# CONVERSION KIT

# 637172

## 637170 PTFE DIAPHRAGM SERVICE KIT FOR 1-1/2" & 2" METALLIC DIAPHRAGM PUMPS (REPLACES 637124-44)

RELEASED: 8-24-89  
REVISED: 5-13-10  
(REV. C)

## 637172 CONVERSION KIT BACKUP WASHERS

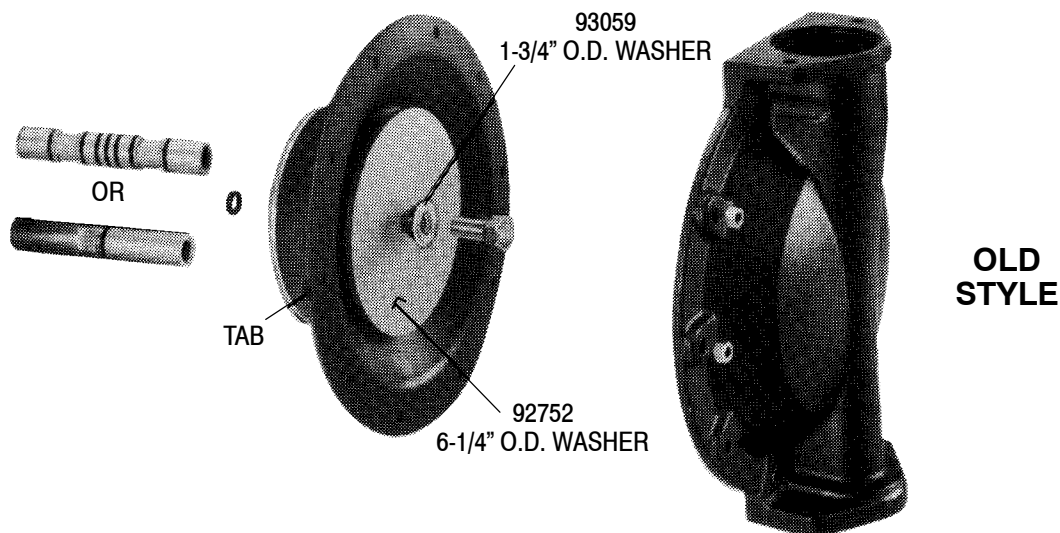
Both kits are required for the first time conversion only.

- The new PTFE Diaphragm profile direction will appear OPPOSITE of the diaphragm being replaced.
- Both diaphragms are clearly marked with "FLUID SIDE" and "AIR SIDE" orientation.
- The old 6-1/4" o.d. washers CANNOT be used with the new two-piece diaphragms.
- After the conversion only the 637170 Service Kit is required for normal scheduled maintenance or repair.
- When replacing diaphragm rod "O" rings in "-C" models use only one of the seven included. (Mfd after 5/88).

### 637170 PTFE SERVICE KIT

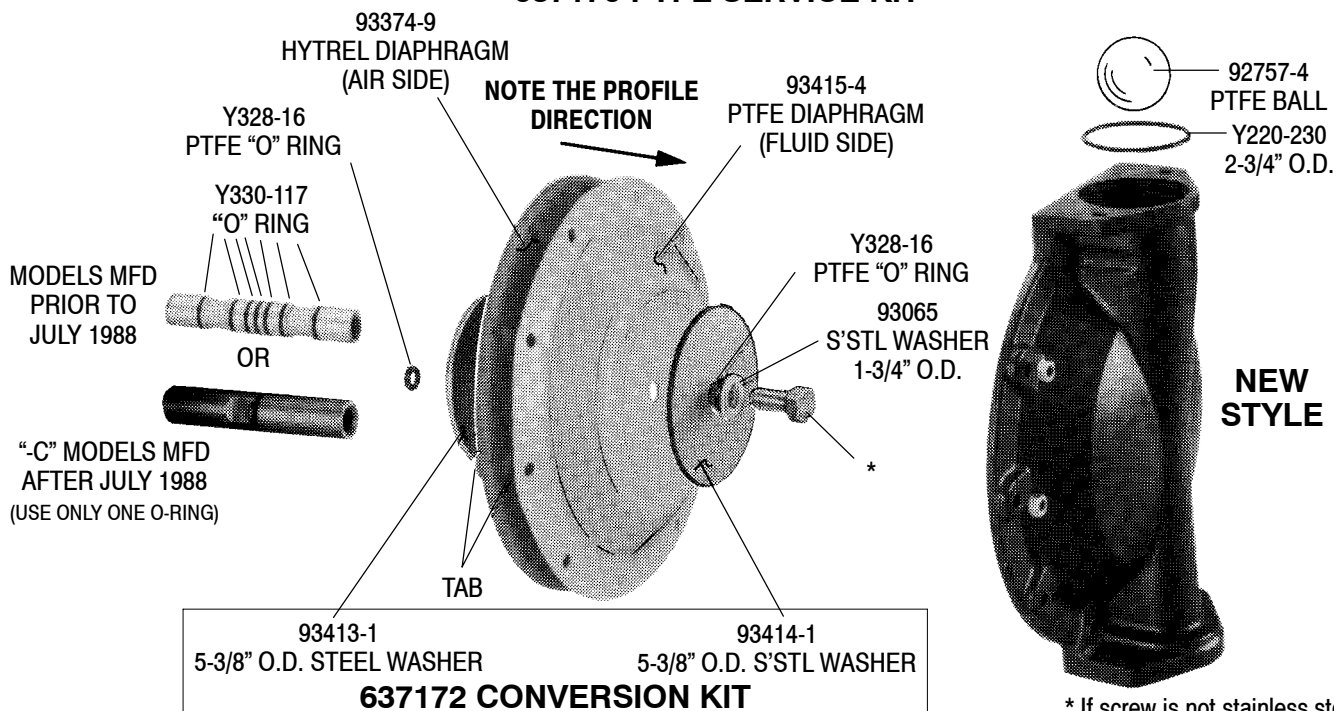
NOTE: RADIUS IS INSTALLED TOWARDS DIAPHRAGM

\* If screw is not stainless steel  
order Y5-107-T separately.
